Planning Application under Section 16 of the Town Planning Ordinance for Proposed Residential Institution (Student Hostel) at Middleton Towers, 140 Pokfulam Road (RBL No. 825 RP) (Application No. A/H10/98)
Submission of Responses to Comments (5th Batch)

Responses to Departmental Comments (5th Batch)

DRAINAGE AND SEWERAGE IMPACT ASSESSMENT

Figure: 3.1		
	Title: Existing Storm Water System in the Vicinity of the Subject Site	
Project: Proposed Residential Institution (Student Hostel) at Middleton Towers, 140 PokfuLam Road	Drawn by: SC	
	Checked by: TC	
	Rev.:	1.3
	Date:	Jul 2026

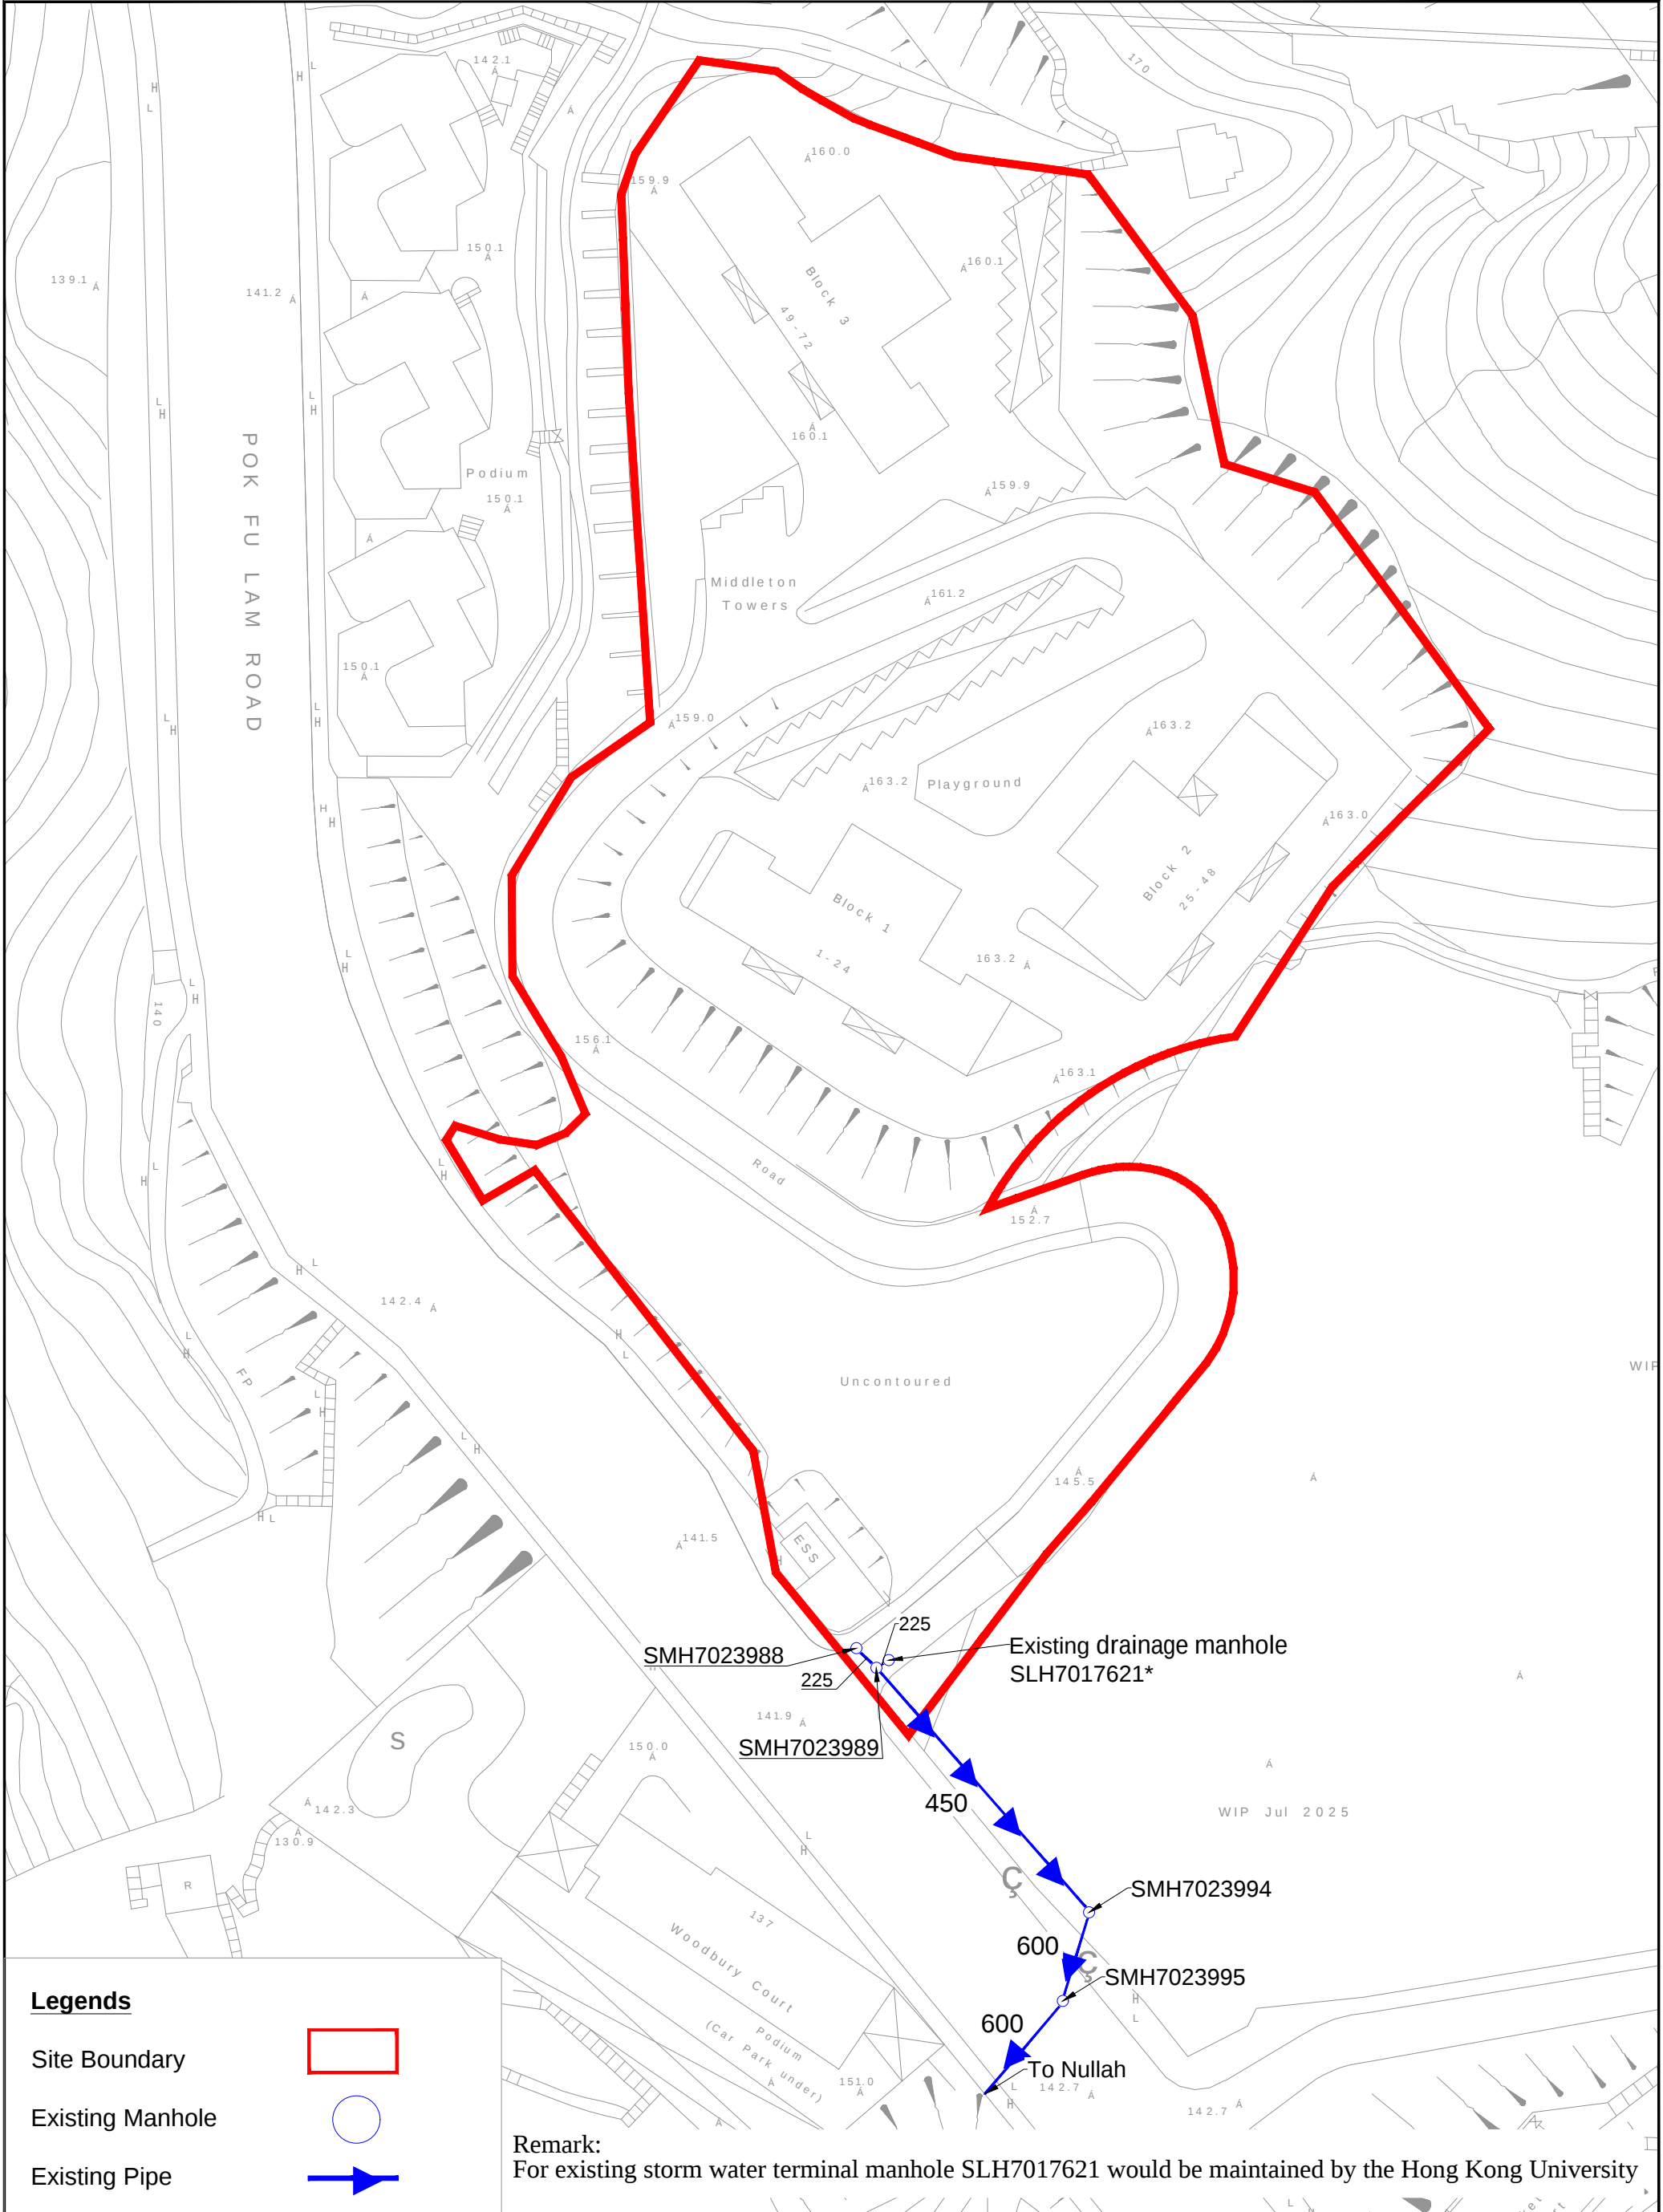
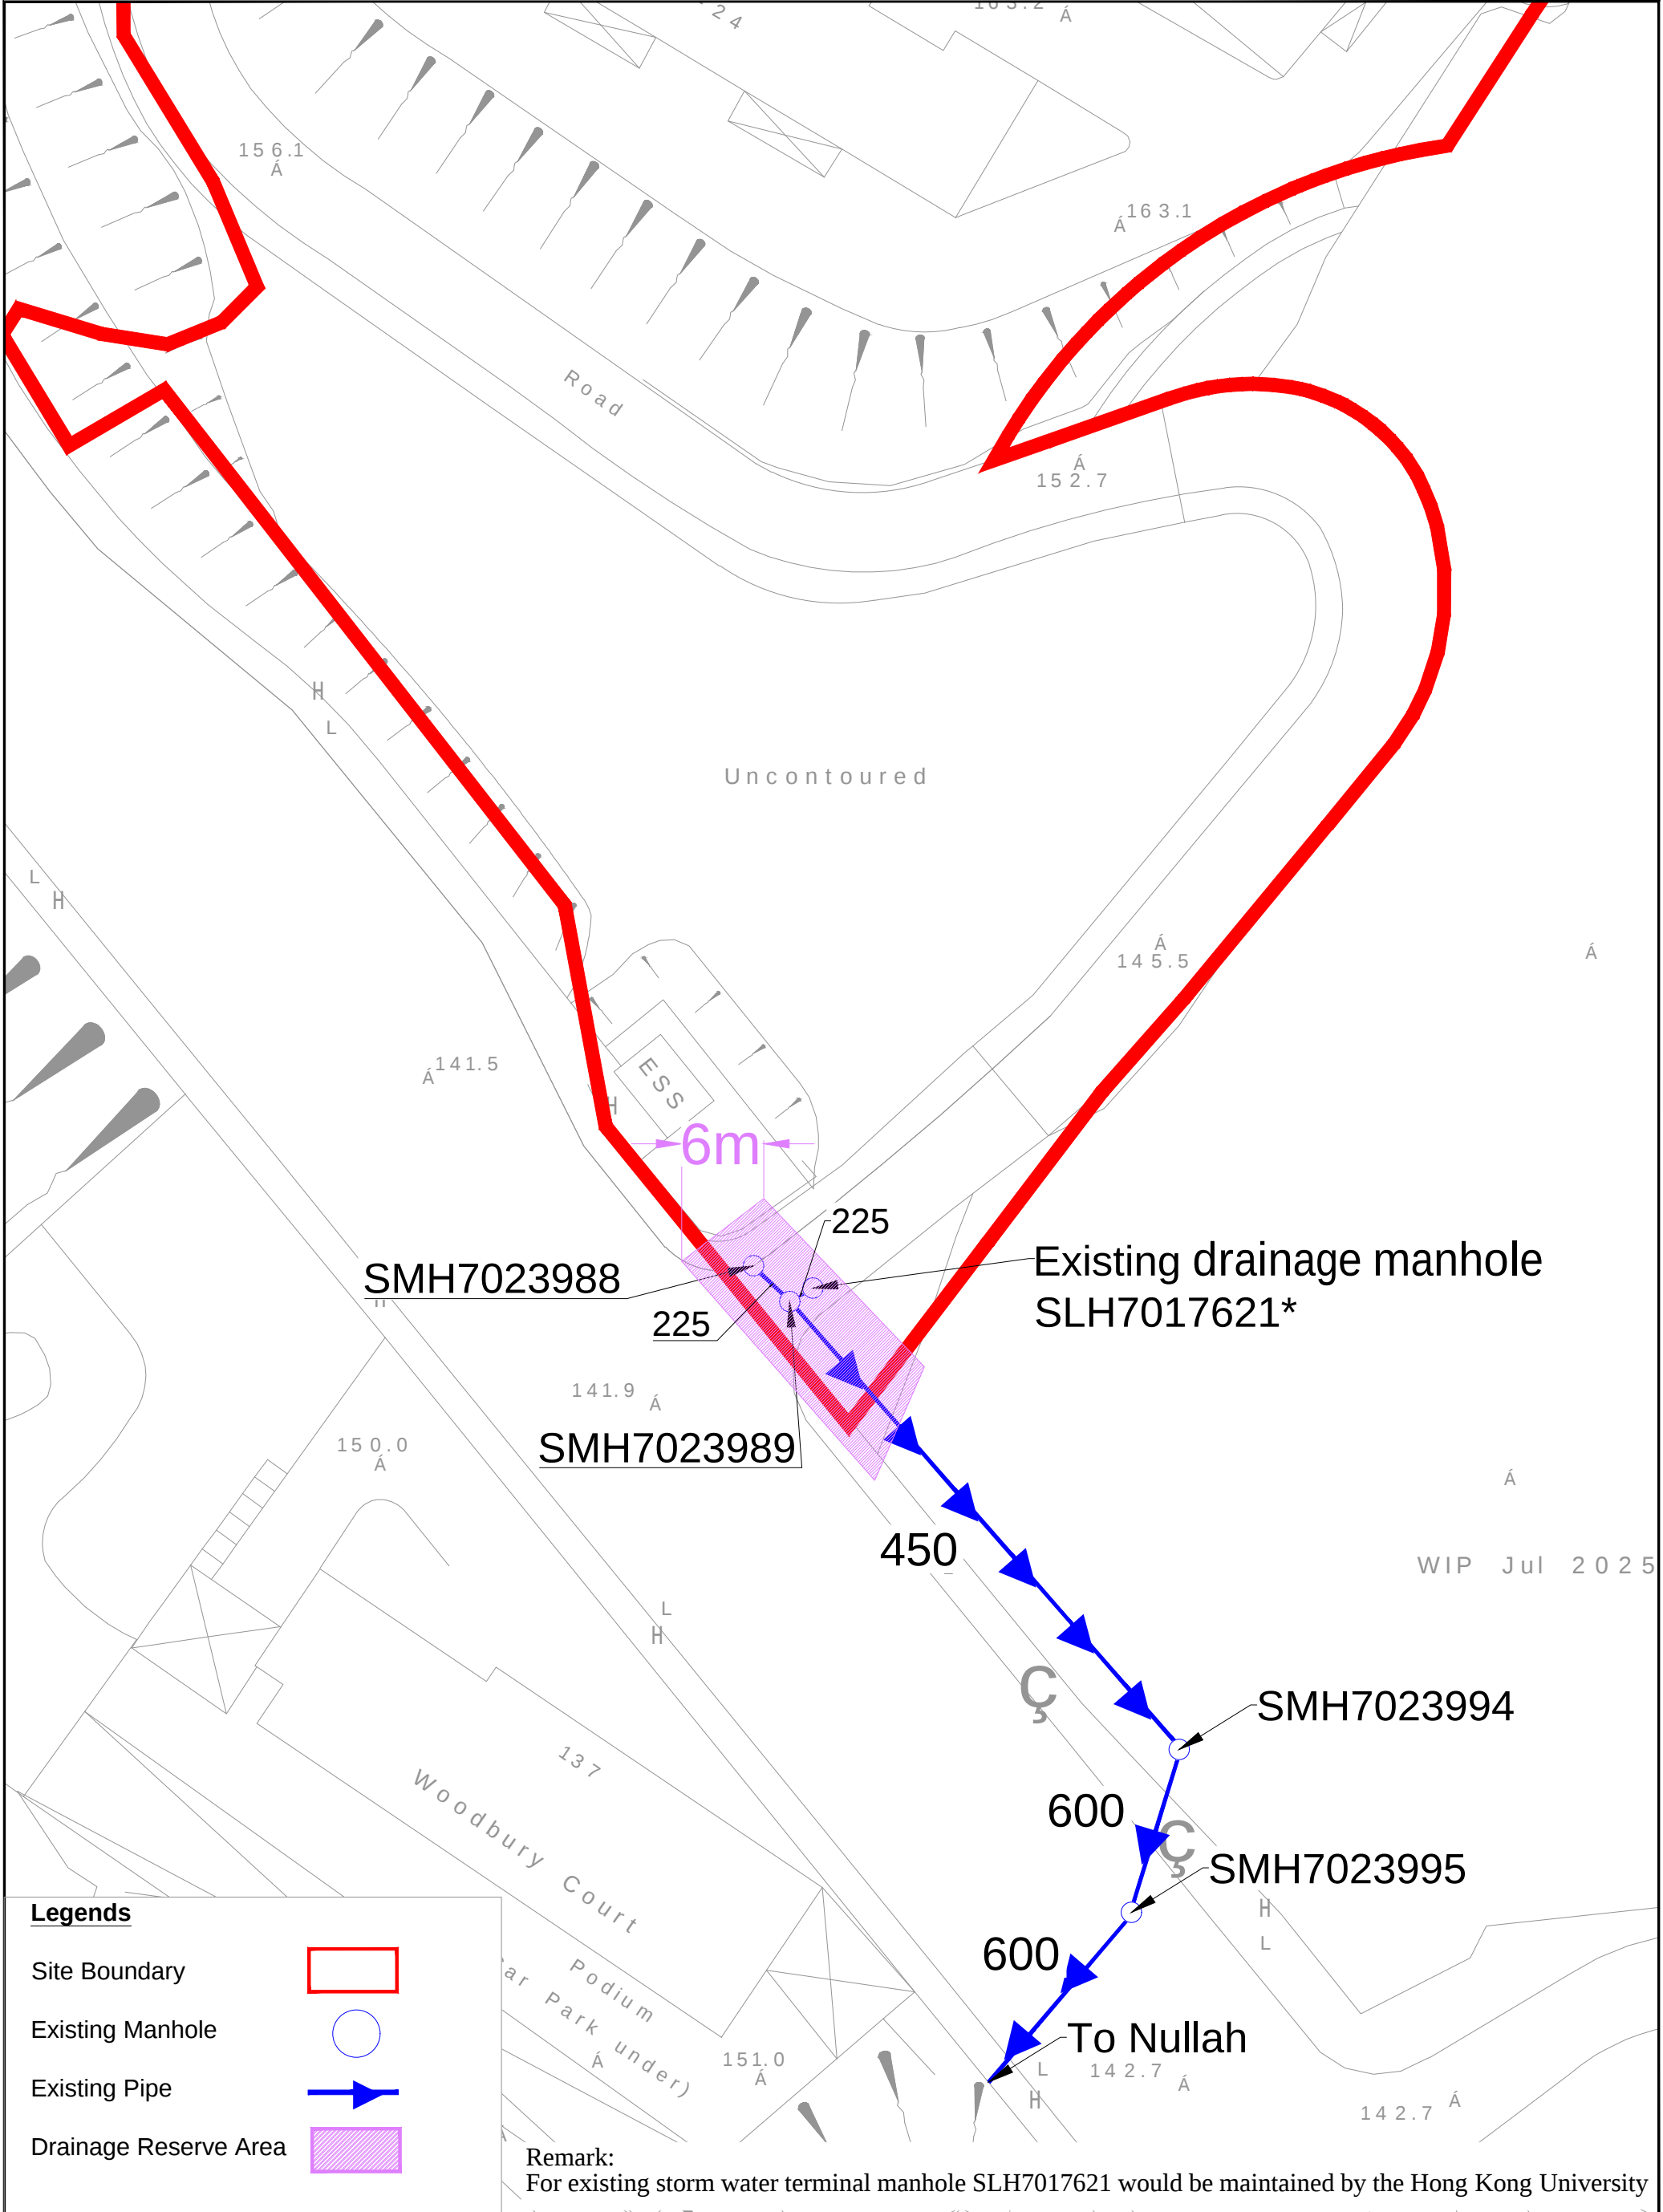
1.3.	Please revise the layouts according to the pdf "mark-up" for accurate and clearer presentation.	Noted and updated accordingly in Figure 2.1 to 3.2.

Figure: 2.3

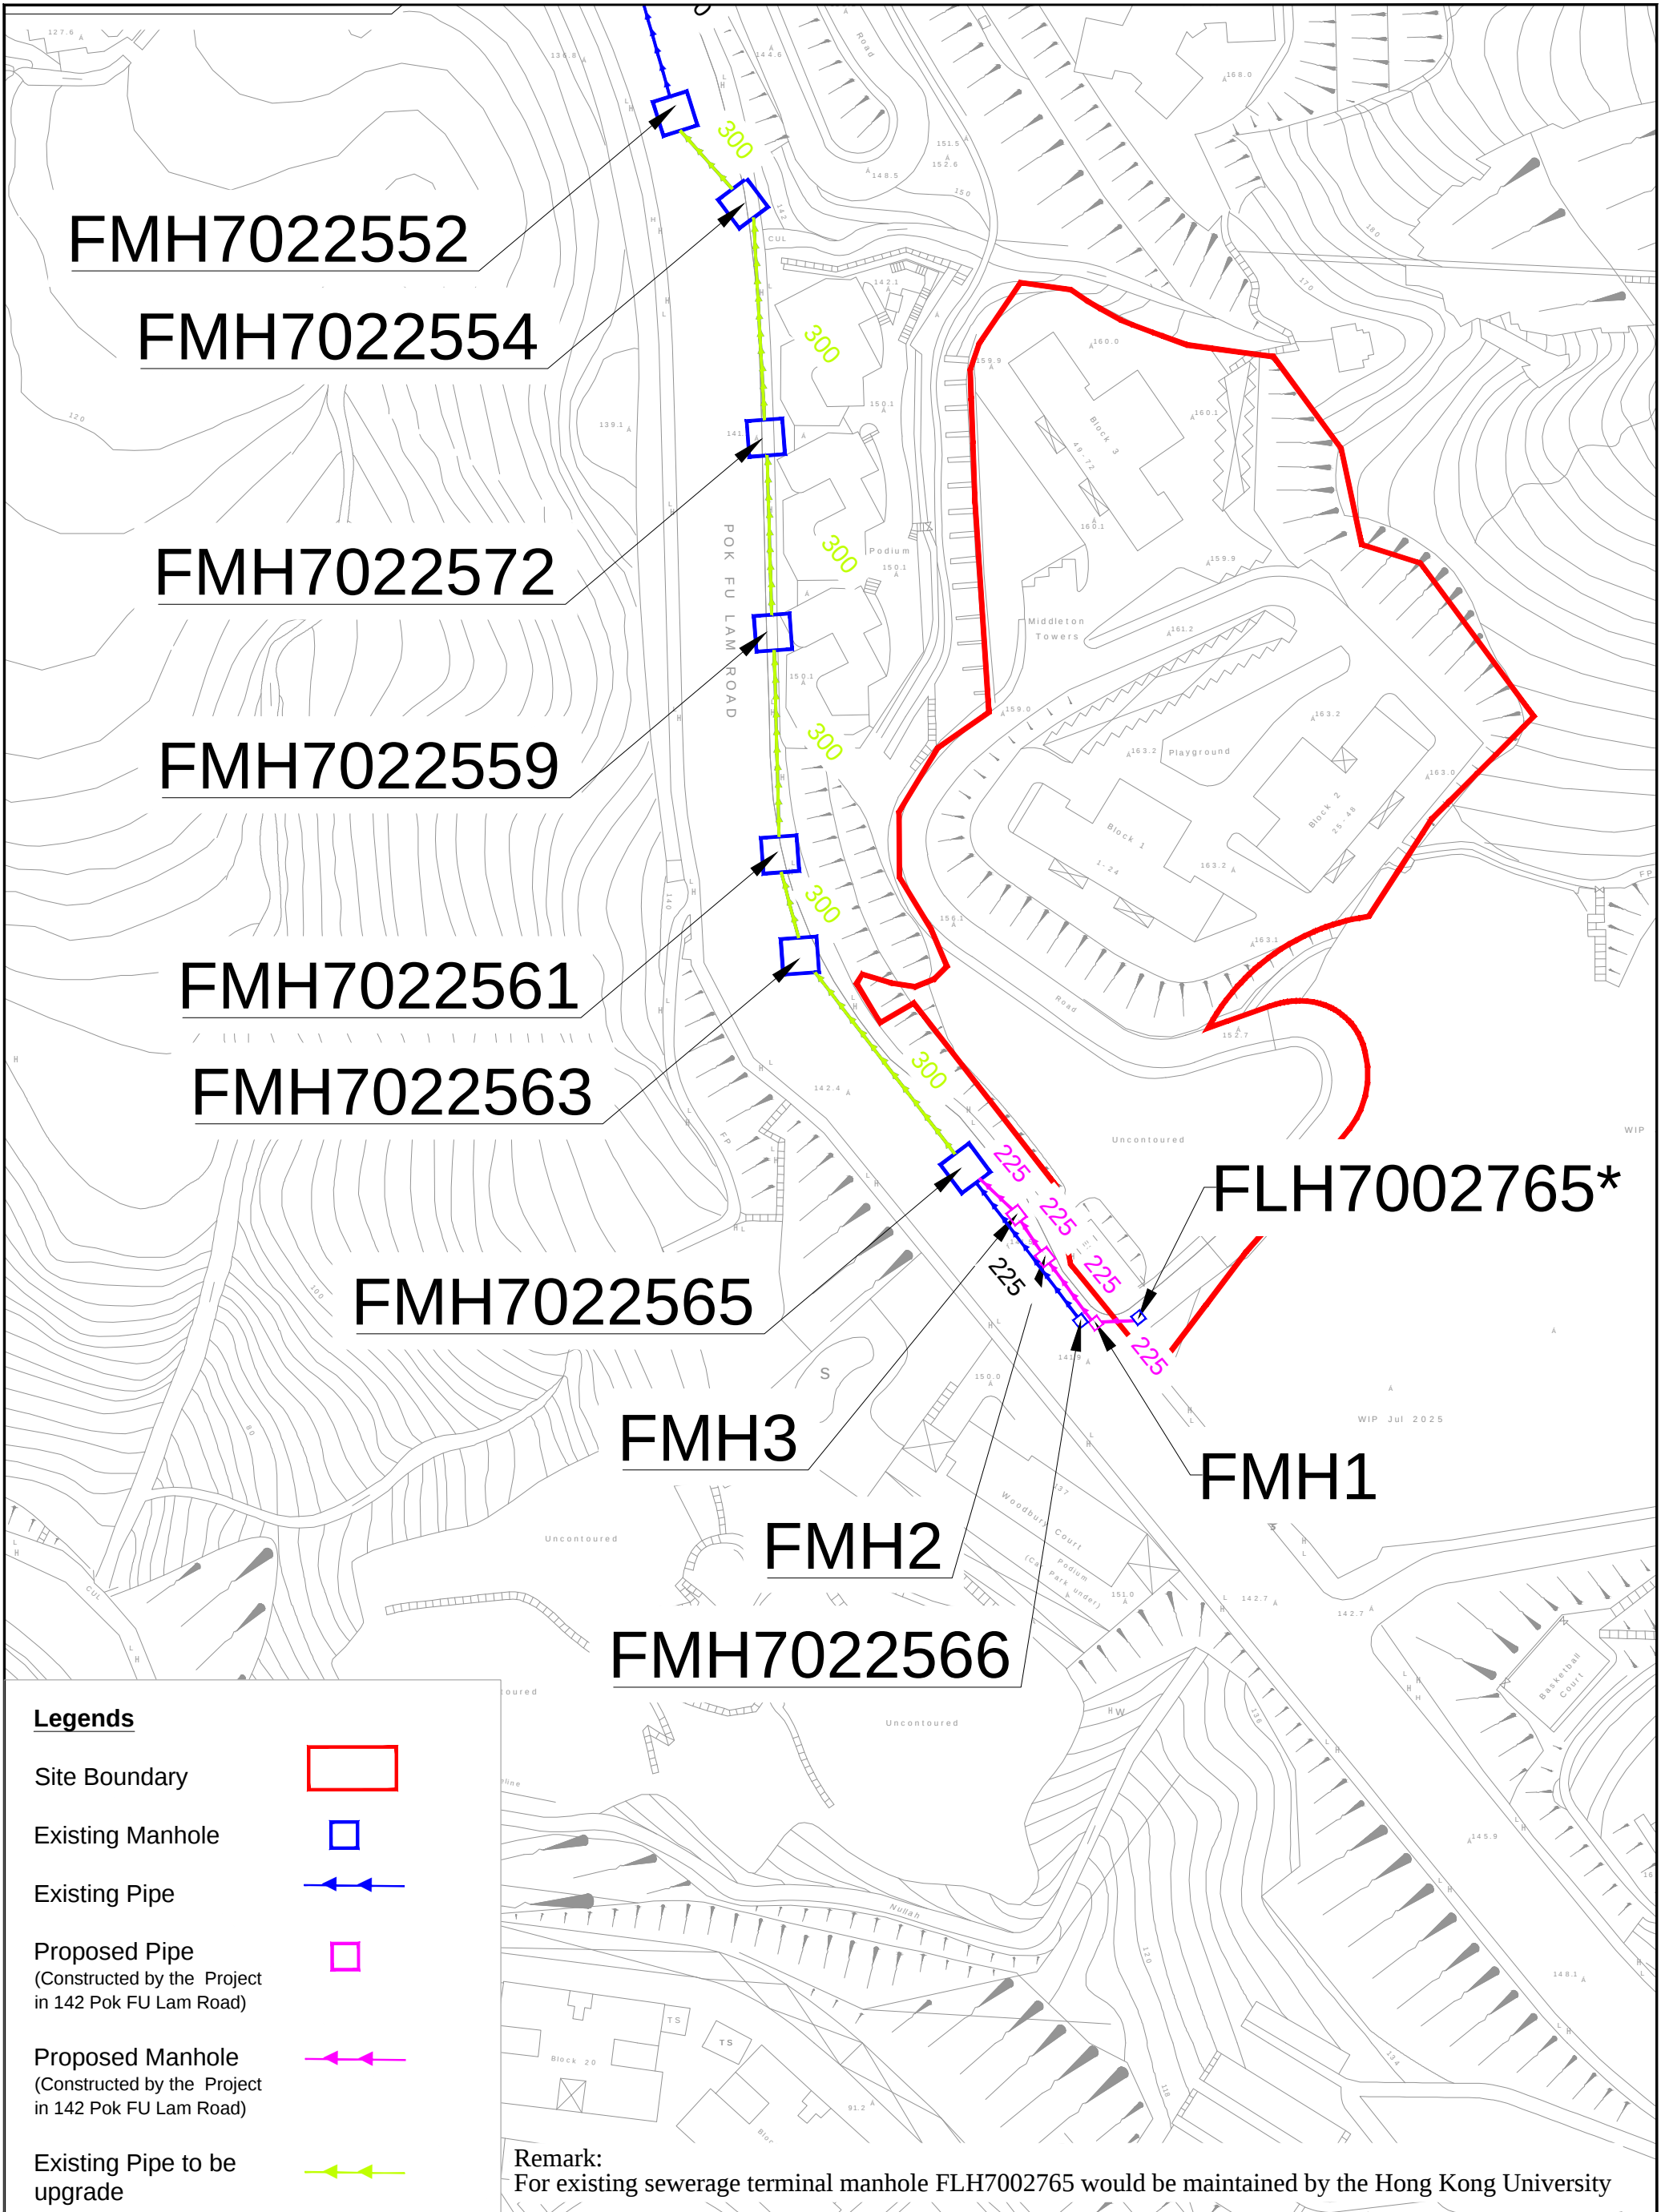
1.1.	Further to Kyle's latest calculations submitted to Desmond (see pdf "Comparison"), FMH7022565 to FMH 7022552 were found to overflow due to the proposed development (900 room student hostel). Therefore upgrading works of the pipes and associated manholes should be carried out by the project proponent before the sewage intake from the proposed development (900 room student hostel).	Noted. The proposed upgrading works is discussed in Section 2.5 of the revised report.

2.5.3 Based on the assessment results, it is found that the capacity of sewers FMH7022563, FMH7022561, FMH7022559, FMH7022572, and FMH7022554 are not sufficient for the sewerage generated from the Proposed Development and the surrounding catchment. Therefore, these sewers are proposed to upgrade. The proposed upgrading works are summarized in Table 2.3 and Figure 2.3.
